CITY of MEDINA
Board of Zoning Appeals
September 12, 2019 Meeting

Case No: Z19-15

Address: 333 Foundry St.

Subject: A Variance request from Section 1147.10(f) of the Planning and Zoning Code to permit a 108 square foot, 6 foot tall sign on the building roof when a roof sign is strictly prohibited.

Z19-15
333 Foundry St.
Sign variances
September 12, 2019

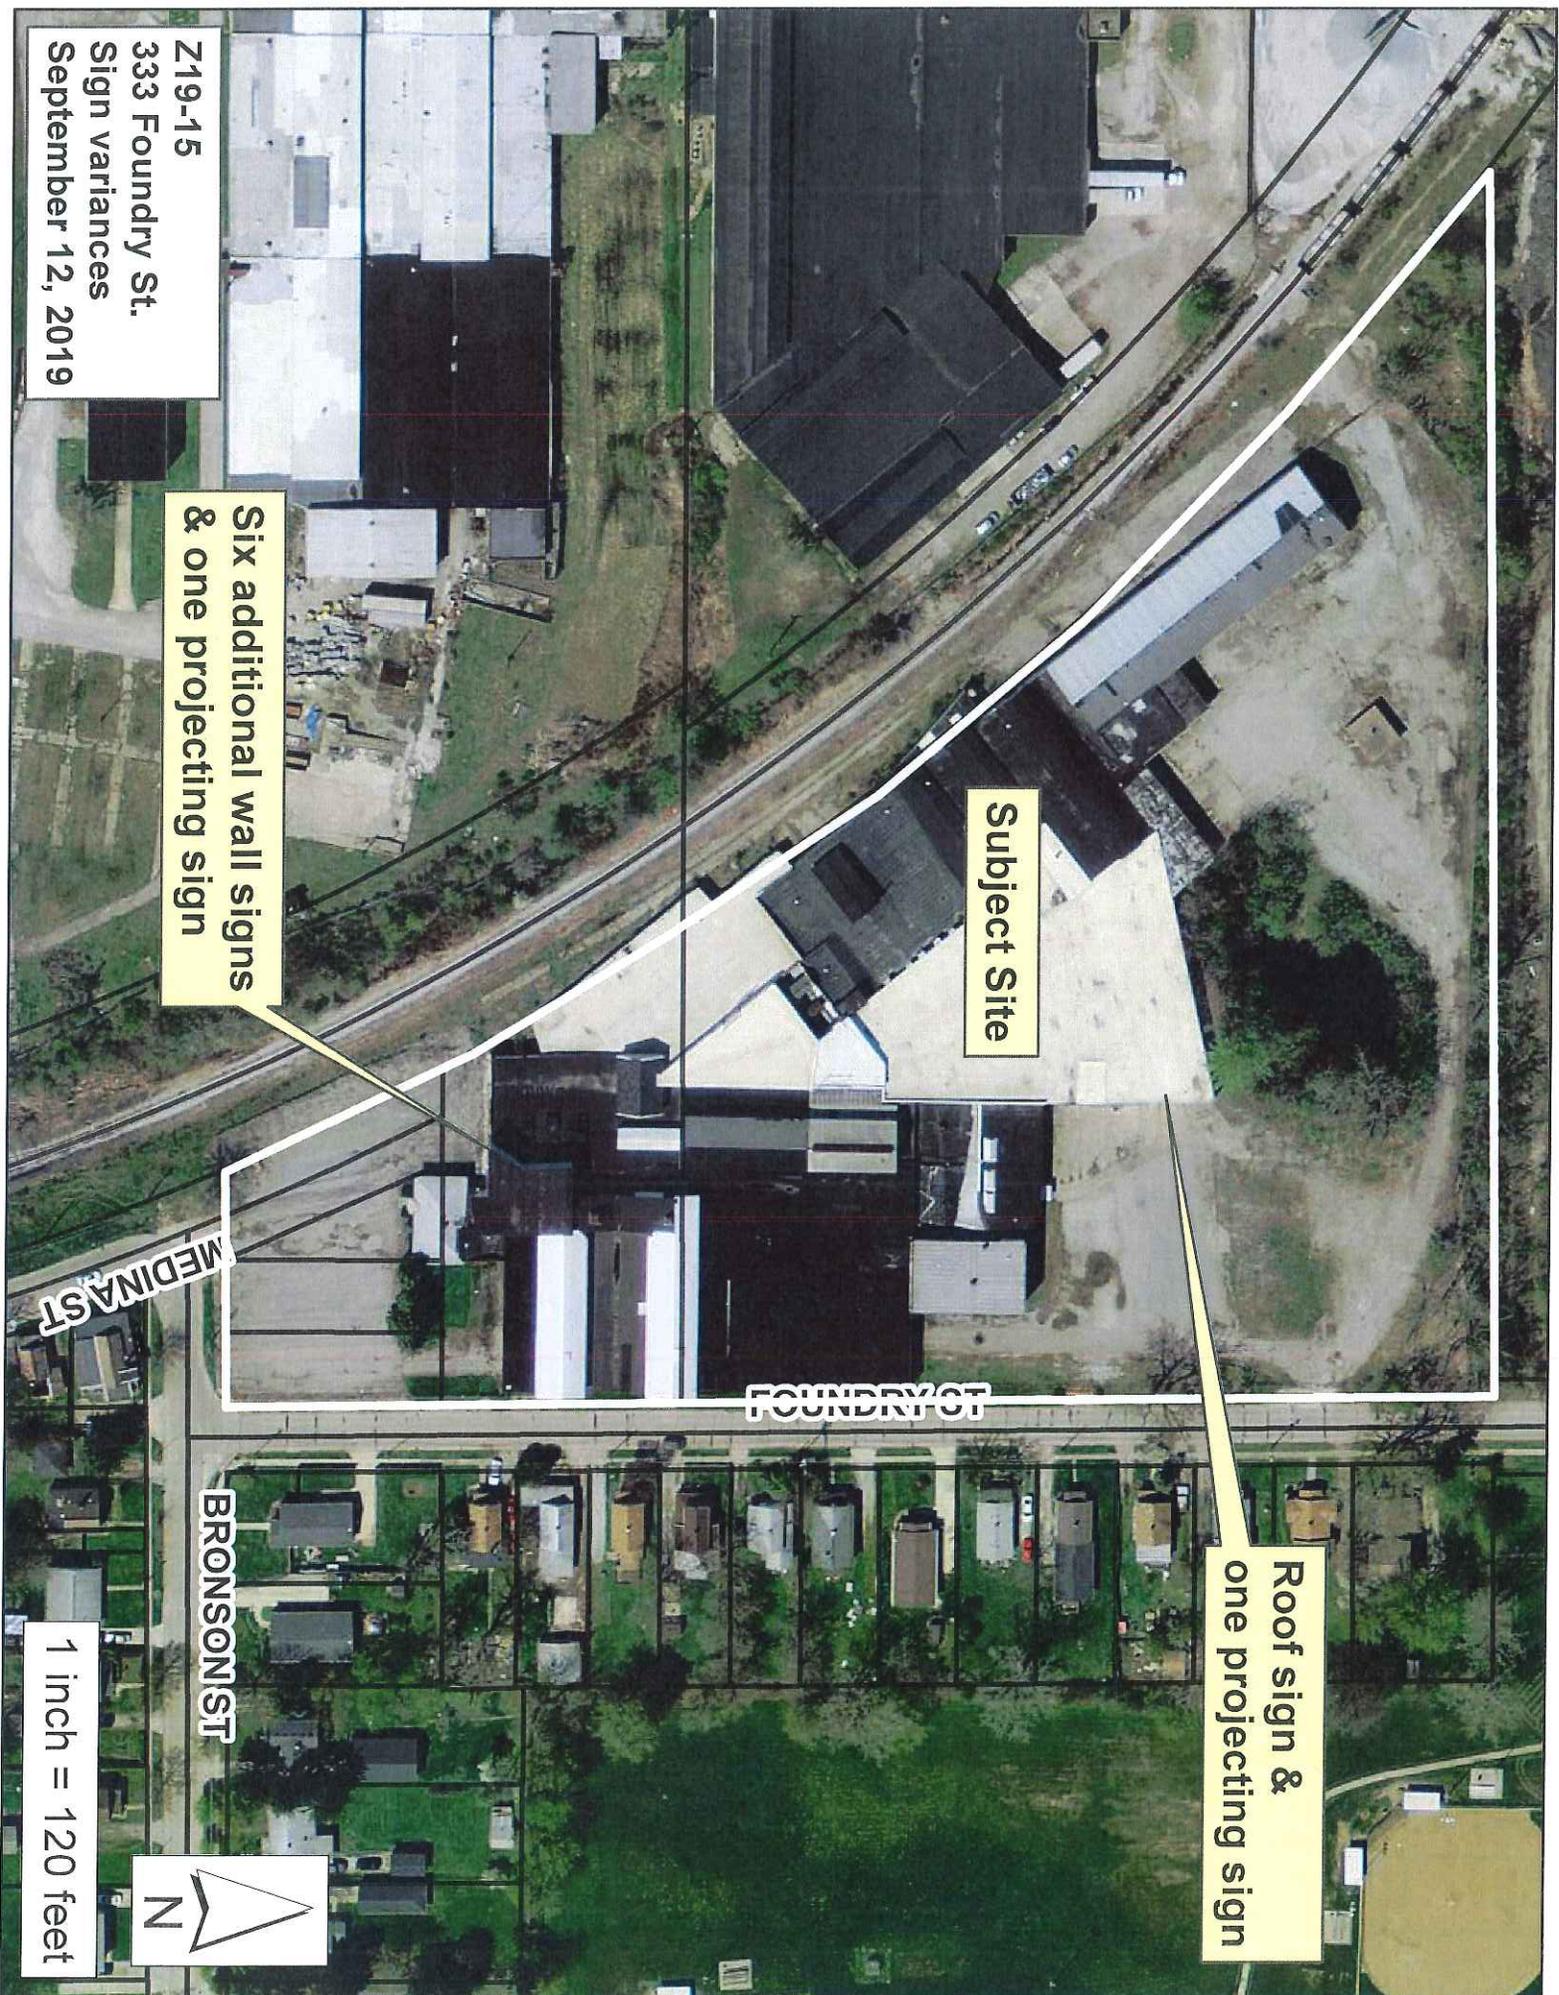
The proposed roof sign is 6 feet tall (above the roof), 108 sqft and located on the northeasterly corner of the building. Roof signs are specifically prohibited.

In addition, the applicant proposes six new wall signs on the south building façade totaling 225 sqft, and two projecting wall signs totaling 25.5 sqft (one on the southwest corner of the building and one on the northwesterly portion of the building).

The proposed wall signs on the building's south side will exceed the maximum allowed 125 sqft of sign area by 100% (proposed – 225 sqft, max. allowed – 125 sqft).

The proposed roof sign and projecting wall signs are prohibited sign types for this property and need to be evaluated within the context of the proposed sign area and the scale of the subject site/building.

The proposed roof sign may impact the character of the site and/or neighborhood due to its prominence and visibility.

Exposed Channel letters

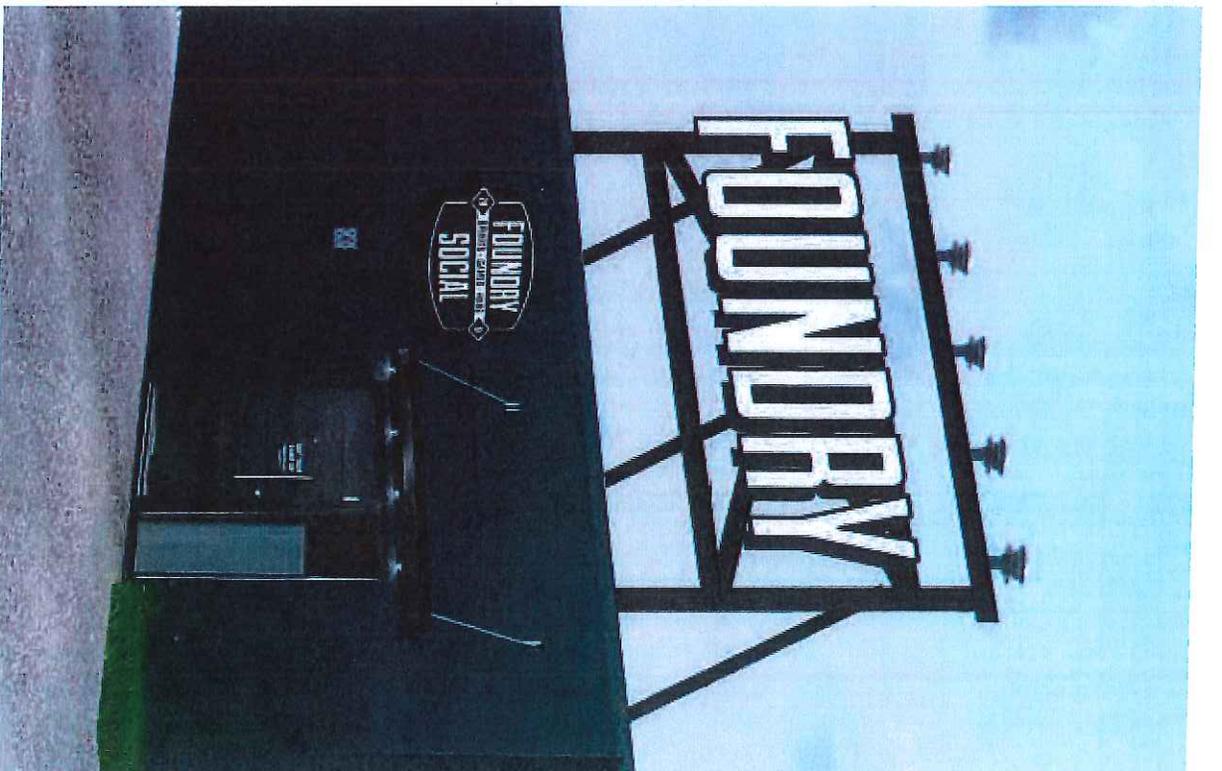
The second issue for the board relates to section 1147.10(f) and the use of the roof sign on the north entrance. Here the selection of the structure and the roof sign is done primarily as an aesthetic response to the character of the building. As an old industrial building, the complete already has some old roof structures that were used to support utilities. The goal was to building upon this imagery. From a functional standpoint, there is no other signage currently proposed for along Foundry Street. The north entrance sits back off of the road and is not easily seen from the road. The roof sign raises the sign up high enough so it is more easily seen from the road, facilitating safer vehicular traffic on Foundry Street because people will be more able to easily identify the facility and the entrance to the parking.

SIGNAGE PLAN
SCALE 1" = 30' - 0"

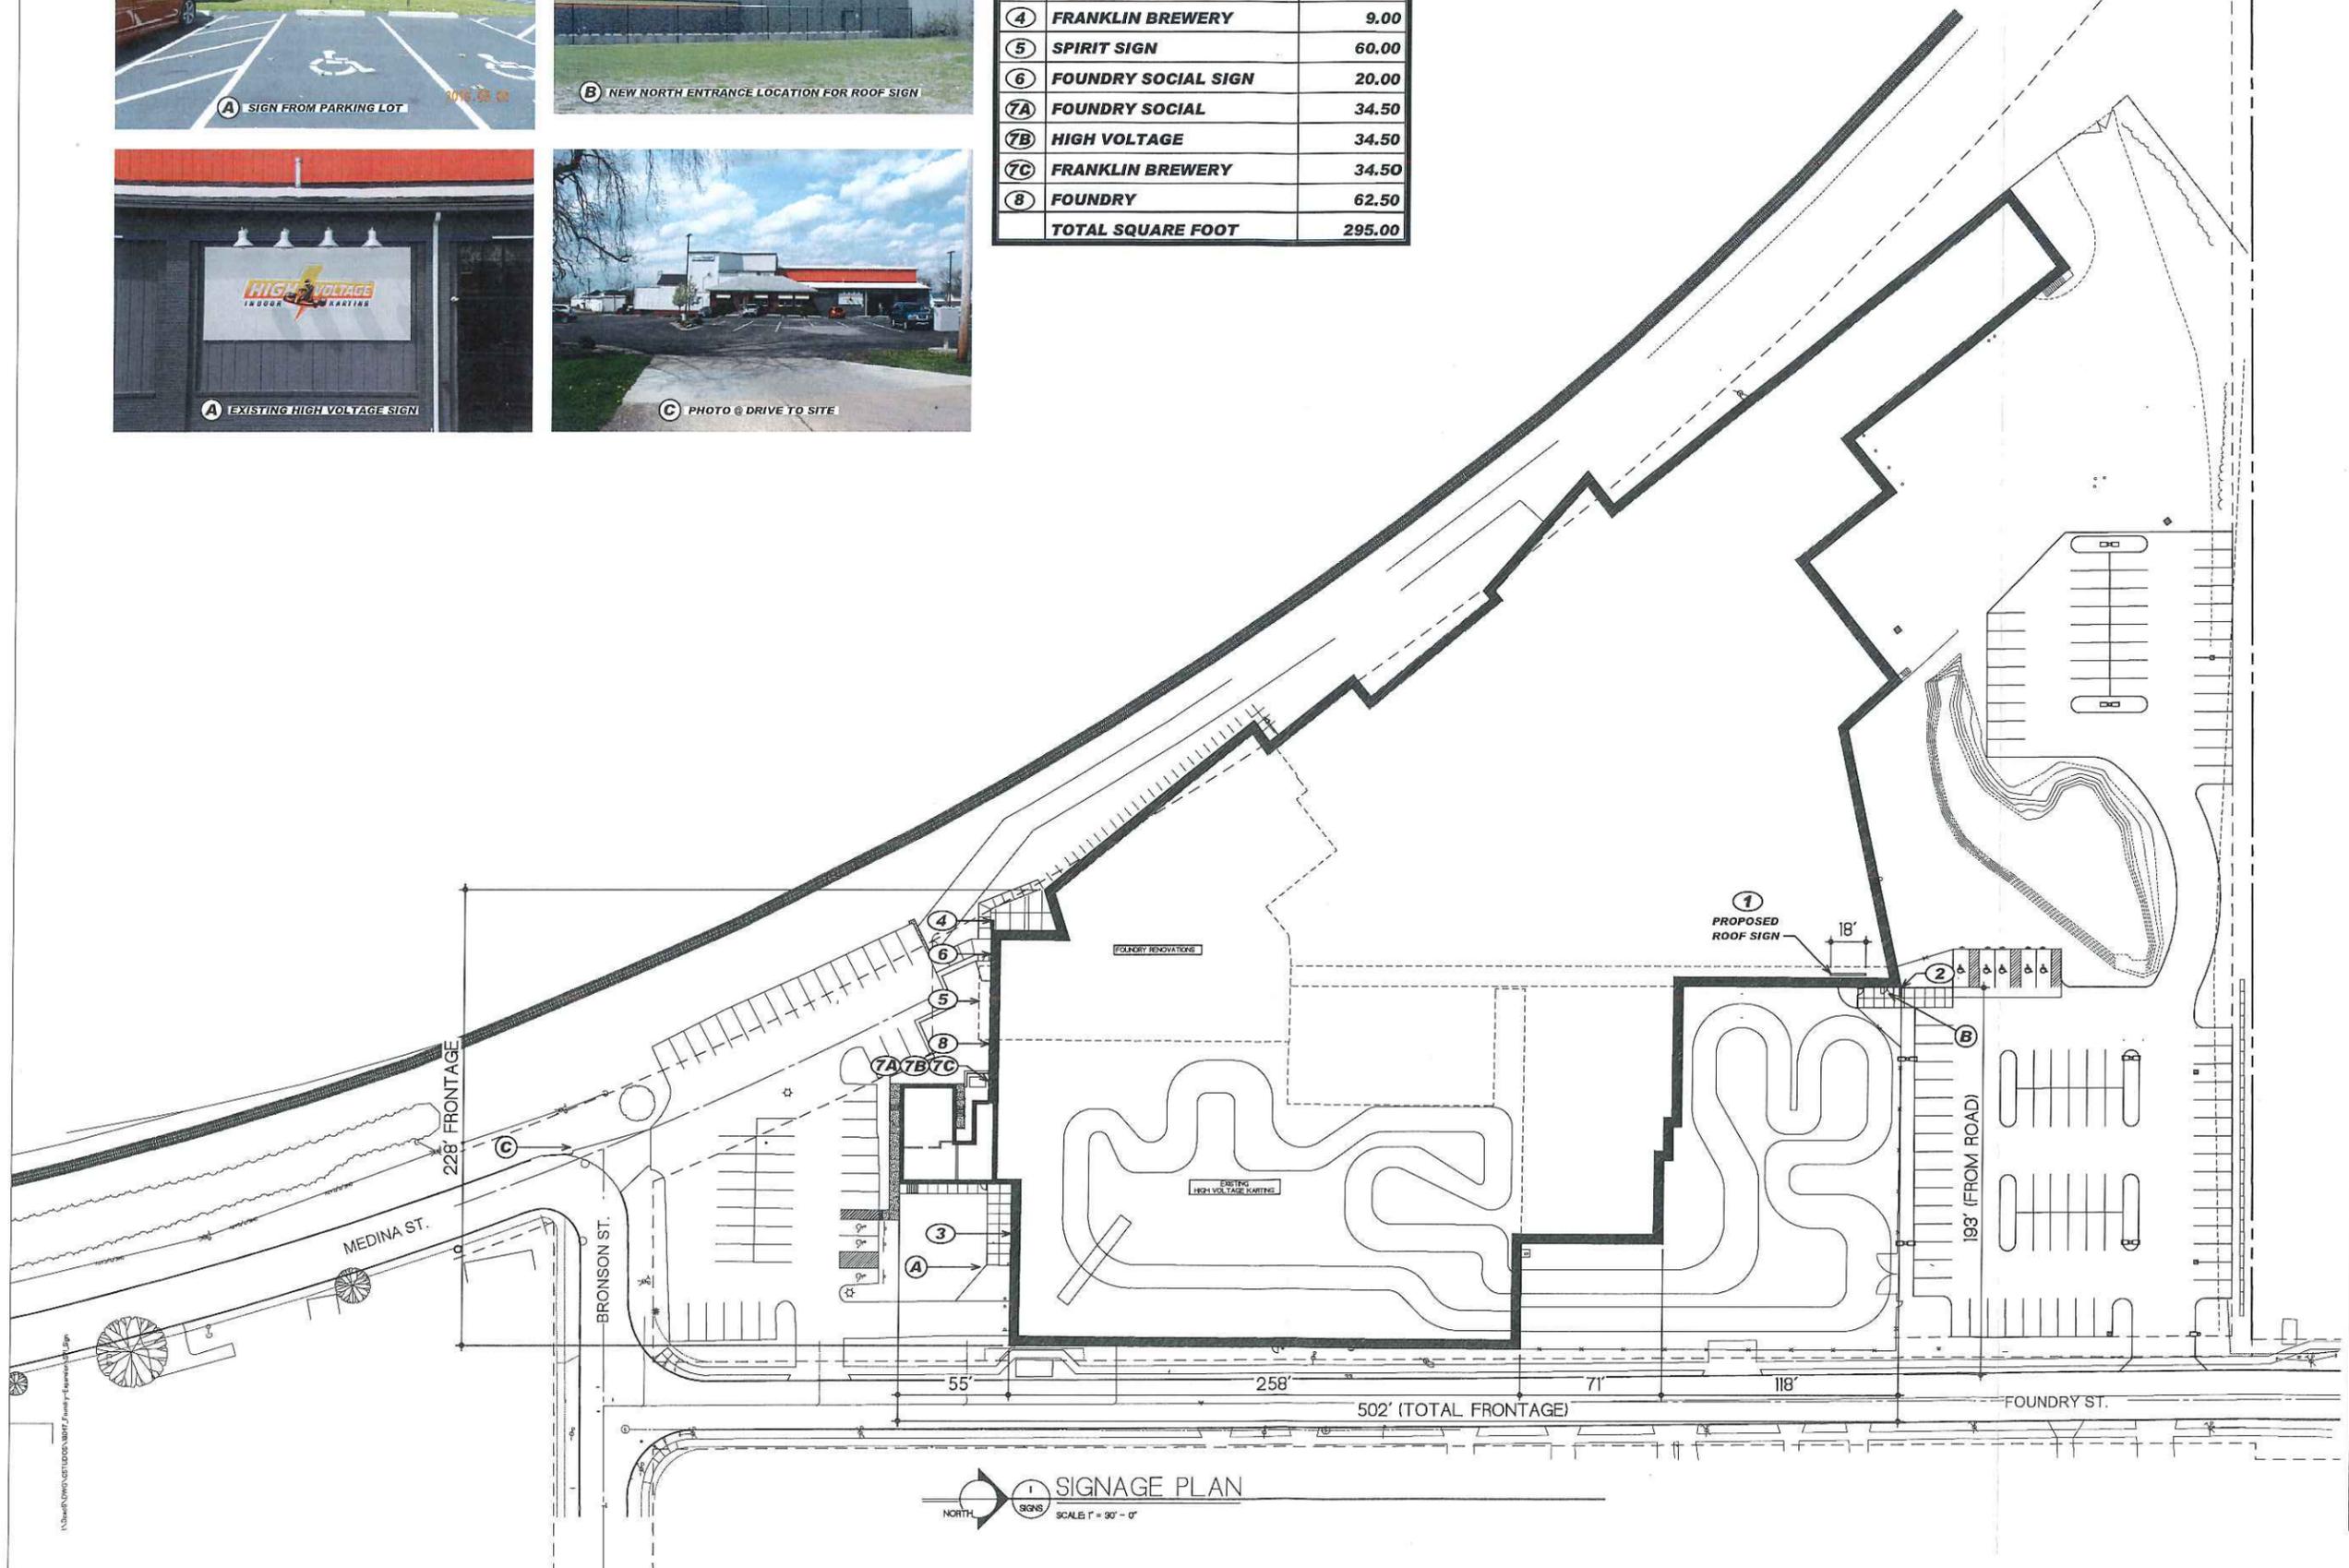
Specific to Section 1147.14(d), Mr. Mendel states that six signs are proposed on the south facade, but only one sign is allowed. In his assessment, he is not addressing the current High Voltage sign, but I think it is important to look at the building signage as a whole. First, under the code, the building is allowed signage on the primary facade at a rate of 1 sf per lf of facade, not to exceed 300 sf. Because the building is on a corner, it also has a secondary facade that allows for 1 sf of sign for every 4 lf of building. Finally, I would say that with the additional parking and entrance to the rear, the building actually has a third facade where signage is warranted.

There is 228' of frontage on the south facade, which would allow for 228 sf of signage. There is 502 sf of frontage on Foundry Street which would allow for 125 sf of signage and there should be an allowance for signage on the north facade facing the parking area. We are aware that the way the signage code is written, each business would be allowed signage based upon the frontage of each business, but that is taking a code that was originally intended for retail shopping strips and trying to apply it to a building that lacks any real similarities to a shopping strip other than to incorporate multiple businesses.

Looking at the signage for the whole complex, we currently have four individual entities. The Foundry, High Voltage, Foundry Social, and Franklin Brewery. Long term, the owners expect many more businesses within the facility there will be a need to address signage for all the businesses, even though future businesses will not have any frontage. Total signage allowed on the building would be a minimum of the 228 sf plus the 125 sf for a total of 353 sf and in reality, additional sf should be allowed for the north parking area. In the sign table we have included on the drawings, we are showing a total of 416.75 sf.
